Fingerboards Mineral Sands EES *Groundwater impact assessment*

Associate Professor Matthew Currell
Environmental Engineering
RMIT University

Scope of my assessment

EES predicted mounding contours after 5 years mining

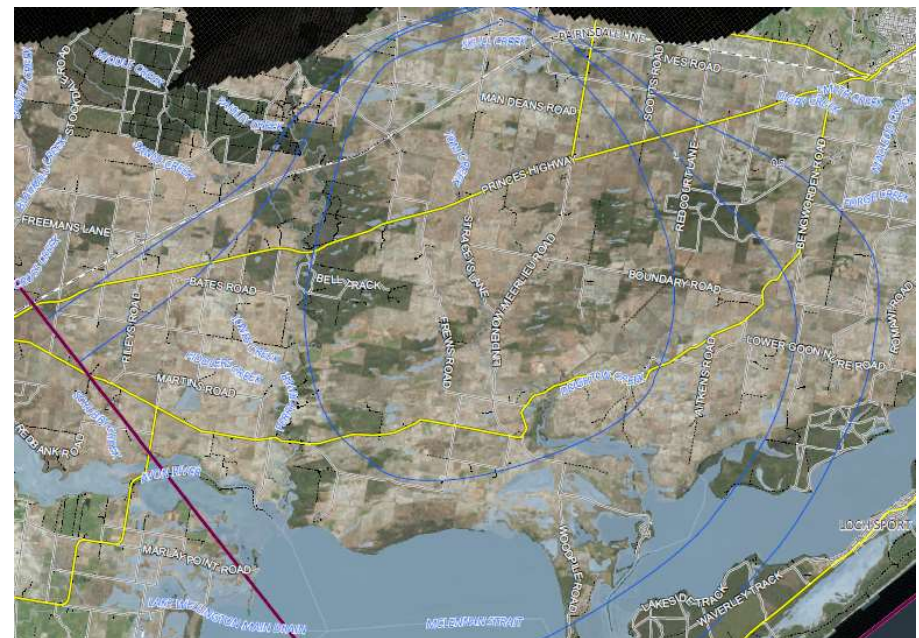
1. Groundwater mounding & movement of contaminants away from the site (e.g., toward surface water & GDEs)

Perched water(?)

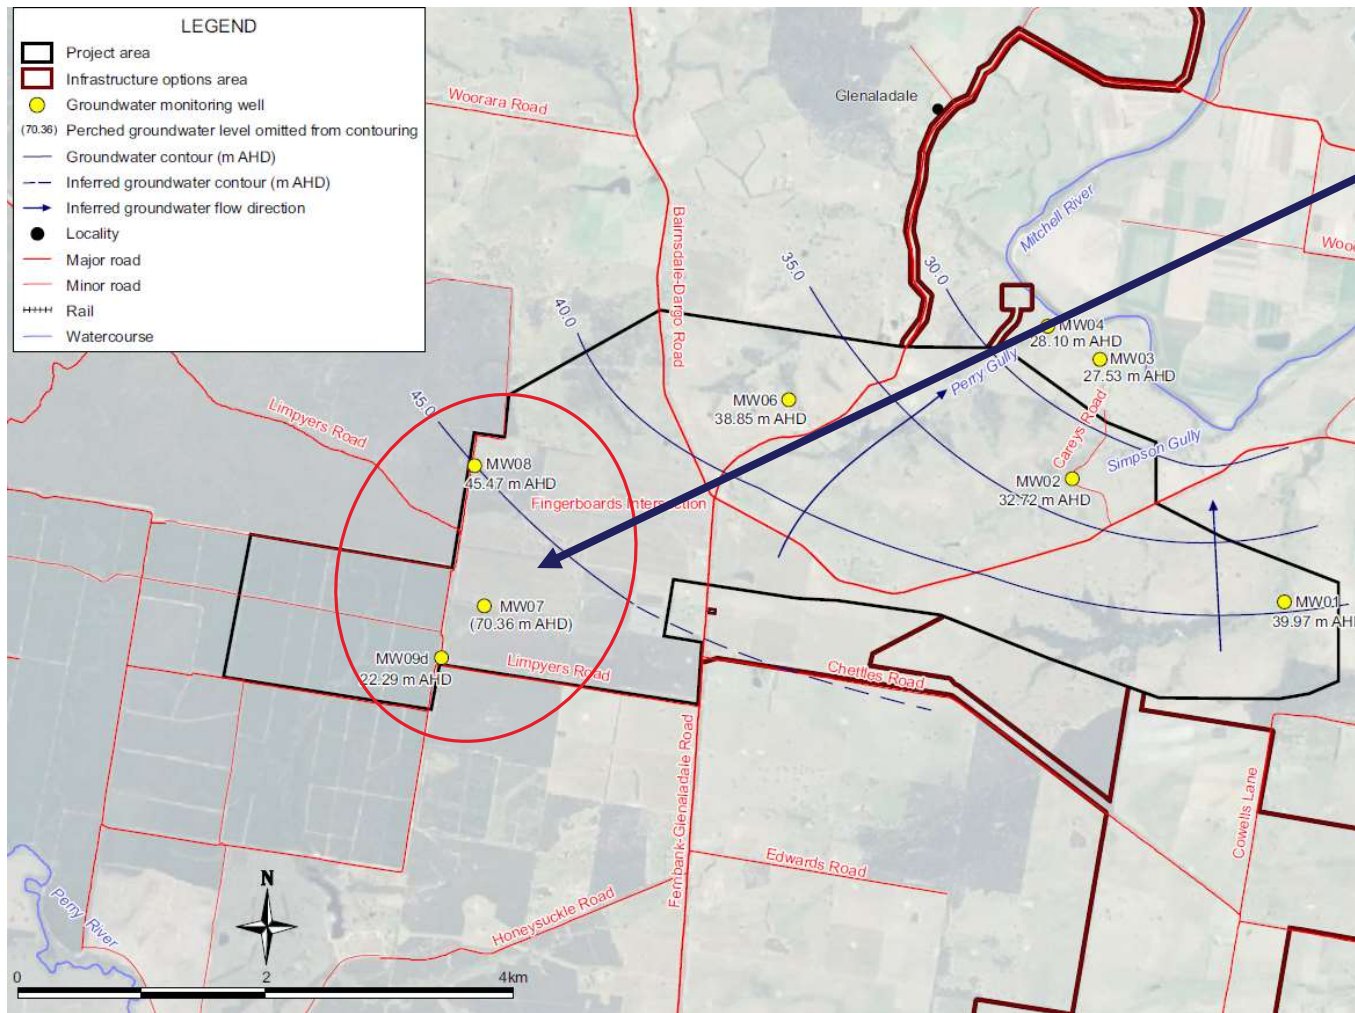
- So far, mechanism and likely extent of perching has been hypothesized, and explored through drill hole water ‘strikes’ but not resolved conclusively at key receptors (e.g. Perry River).
- Unclear how far (and how quickly) perched water might move in response to increased seepage below the mine
- Could form new surface seeps with potentially poor water quality ‘daylighting’.

- MW7 water level significantly higher than nearby bores
- This (and other) bores have poor groundwater quality including high nutrients and heavy metals concentrations
- Cause of these water quality issues not thoroughly investigated (legacy contamination?)
- Potential risk of mobilizing contaminants to the surface?

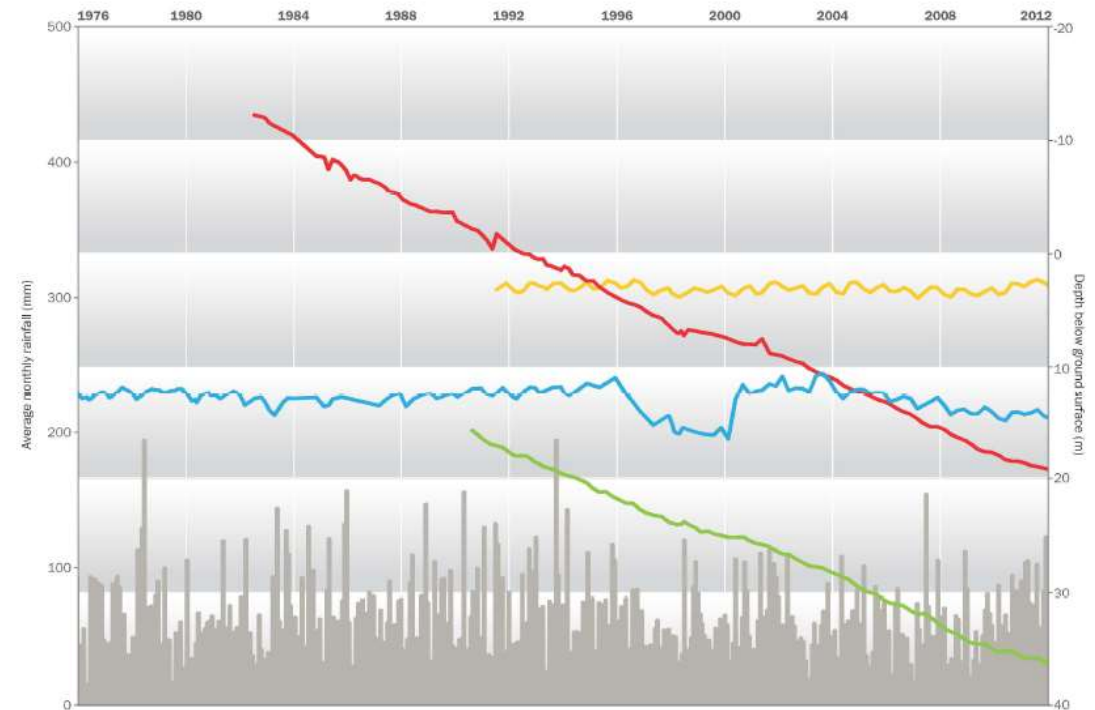
Target aquifer (Latrobe) already experiencing significant long-term drawdown due to mining, oil & gas and irrigation

- Southern Rural Water: Aquifer is already fully allocated and extraction > recharge
- Unlikely a large (3 GL/yr) license would be granted in this context.
- Is this a viable water supply?
- Implications if either surface water or groundwater licence (or both) not approved?

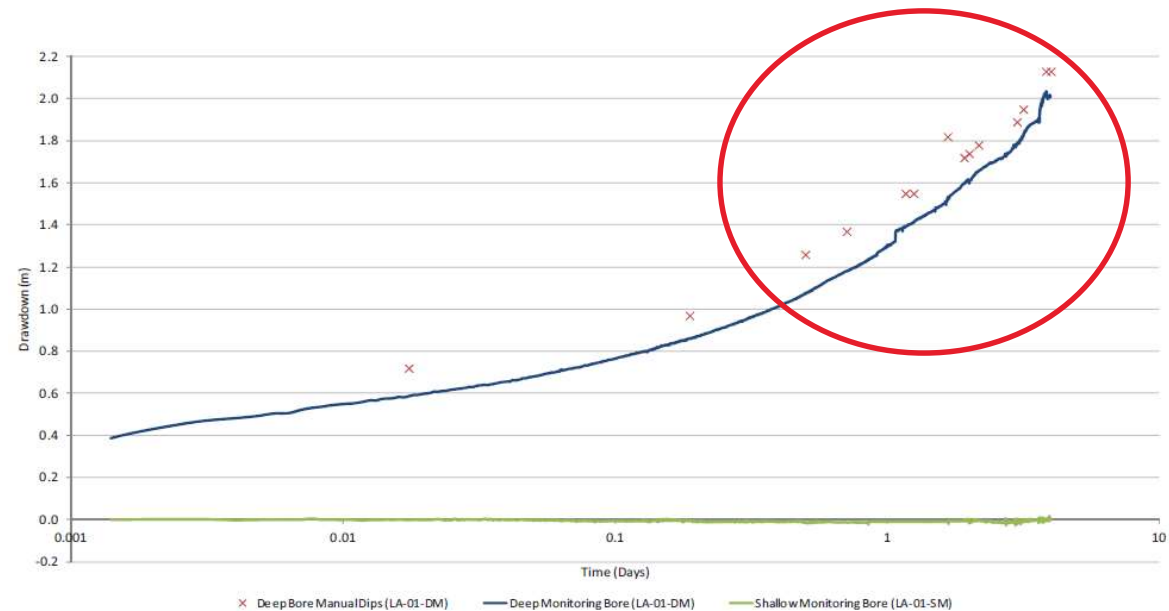
Pumping tests: a sound method to understand an aquifer's response to pumping – e.g., extent of drawdown and potential inter-aquifer connectivity. However, in this case, the test suffered design problems (JER section 2):

- Test period was too short
- Limited monitoring bores
- Pumping rate not steady
- No recovery data recorded.

Missed opportunity to gain better understanding of how aquifer would respond to the proposed bore-field extraction

Modelled Latrobe Group Gravels drawdown/mounding at mine year 3

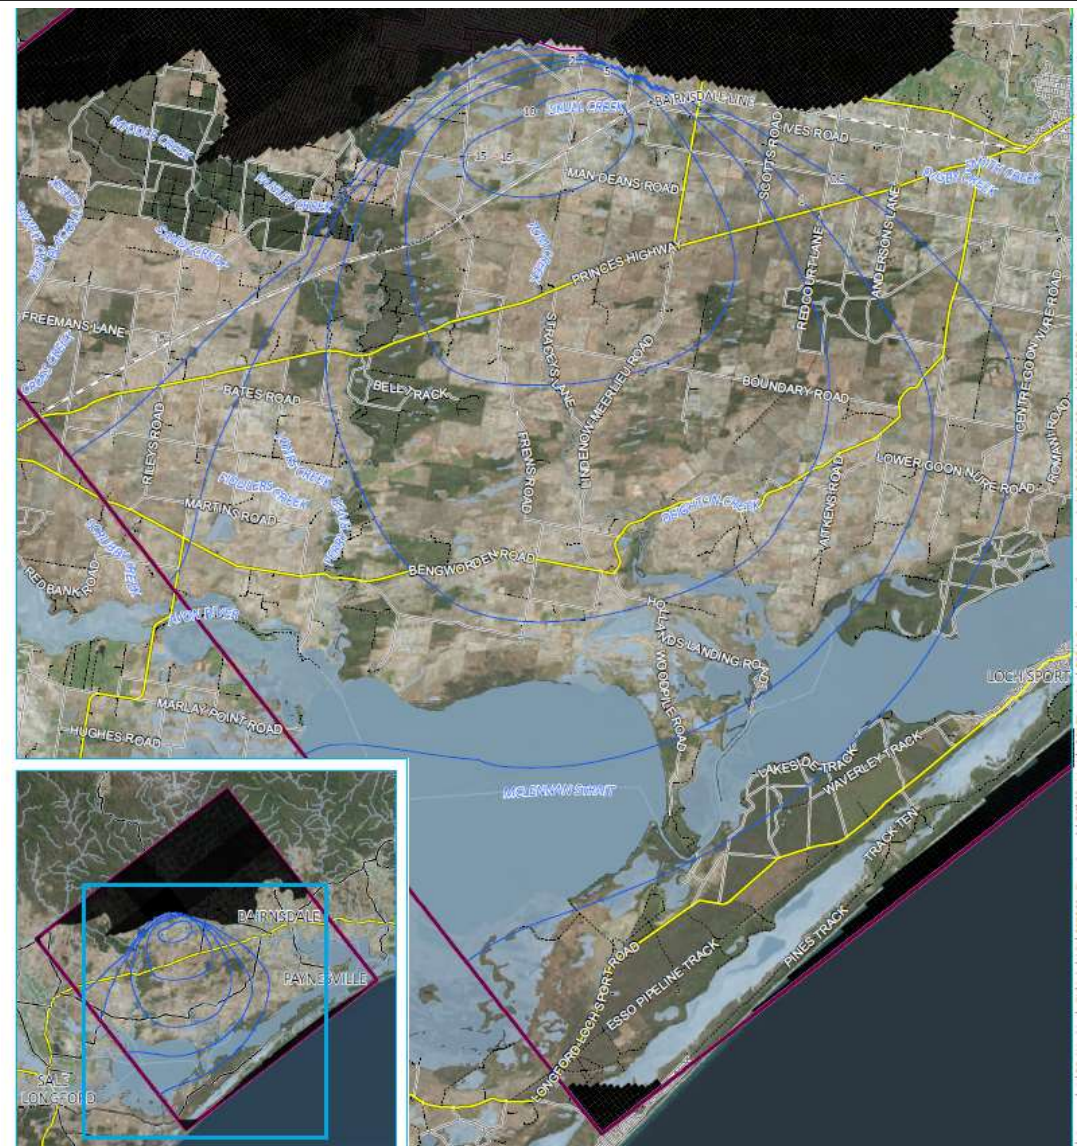
Predicted drawdown impacts: regional in scale

- Indicates a likelihood of borefield drawdown reaching aquifer boundary
- Potential consequences not (yet) considered.
